ALERT SERVICE BULLETIN

505-22-29

MODEL AFFECTED: 505

SUBJECT: ENGINE FUEL DRAIN TUBE AND COMPRESSOR WASH TUBE CLAMPING, INTRODUCTION OF.

Figure 1 – Installation of clamps (sheet 1 of 2)

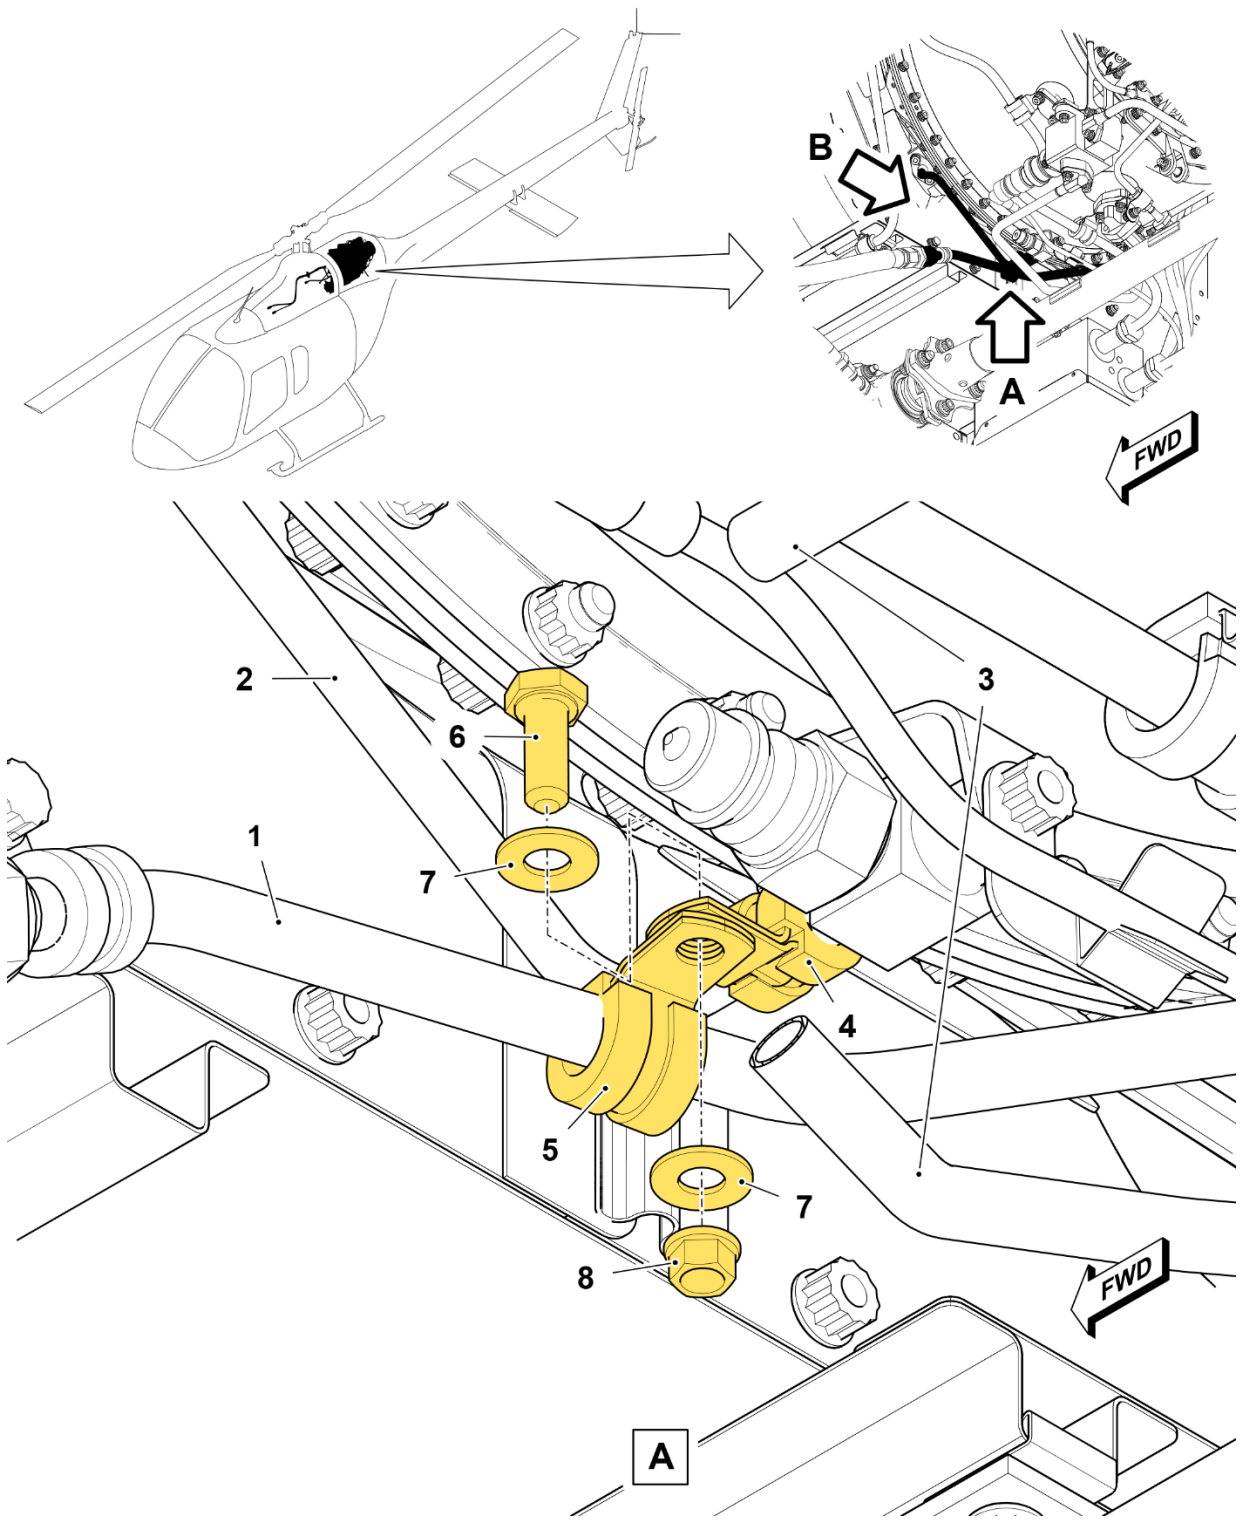
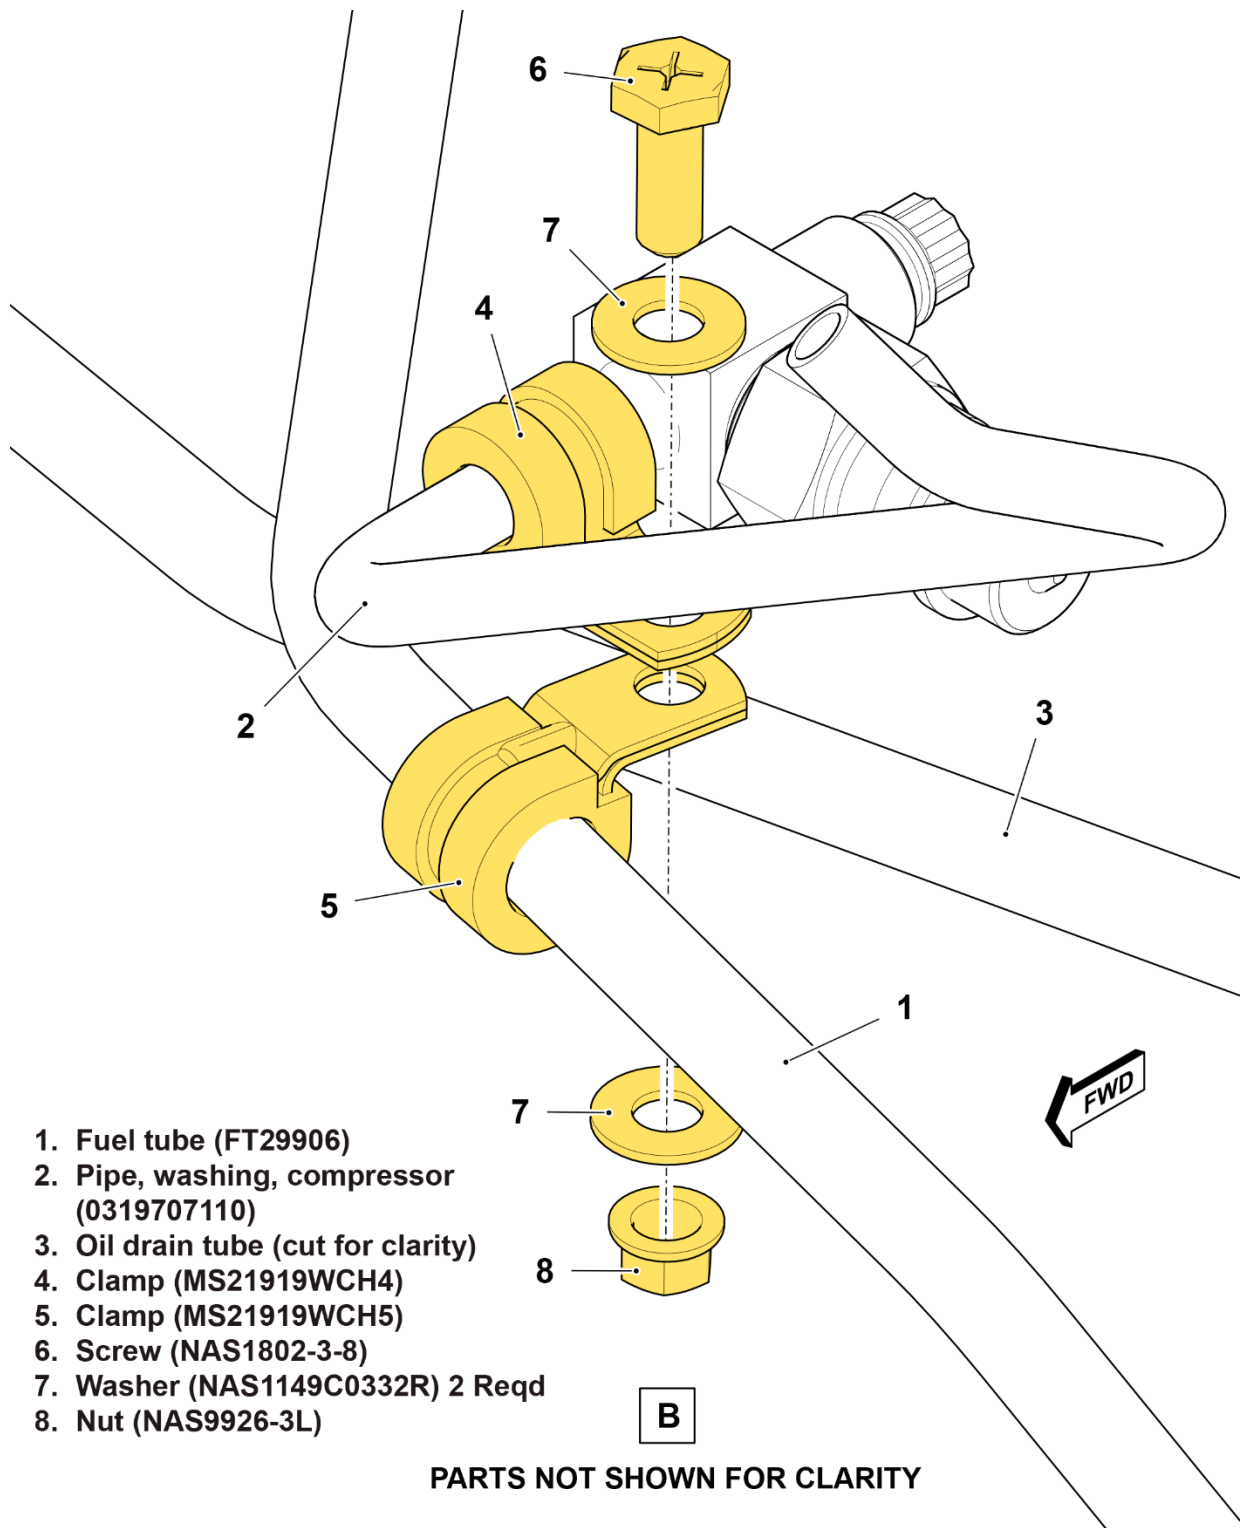
Make sure there is a minimum clearance of 0.010 inch (0.254 mm) between the fuel drain tube (1, Figure 1) and the compressor wash tube (2). Loosening and tightening of the tube end fittings for repositioning of the tubes may be required.

3. Visually inspect the clearance between the fuel drain tube (1, Figure 1) and the engine compressor wash tube (2). If the tubes are contacting each other, or if there is evidence of chafing damage on either tube, go to step 4, otherwise go to step 7.
4. Remove the fuel drain tube (1) ([DMC-505-A-71-70-05-00A-520A-A](#)).

5. If there is chaffing damage on the fuel drain tube (1), measure the depth.
 - a. If the damage depth is less than 0.010 inch (0.254 mm) the fuel drain tube (1) is considered serviceable and can remain in service. Go to step 6.
 - b. If the damage depth is more than 0.010 inch (0.254 mm), replace the fuel drain tube (1) with a serviceable fuel drain tube meeting the intent of the bulletin.

Position of the clamps should be adjusted to achieve a minimum 0.159 inch (4.0mm) clearance between the fuel drain tube (1) and the compressor wash tube (2). Loosening and tightening of the tube end fittings for repositioning of the tubes may be required.

3. Install the clamps (4 and 5, Figure 1) with screw (6), washers (7) and nut (8). Torque the nut (8) 30 to 40 inch-pounds (3.4 to 4.5 Nm).
4. Install the aft engine cowling (443T) ([DMC-505-A-71-10-02-00A-720A-A](#)).
5. Make an entry in the helicopter logbook and historical service records indicating compliance with **PART II** of this Alert Service Bulletin.
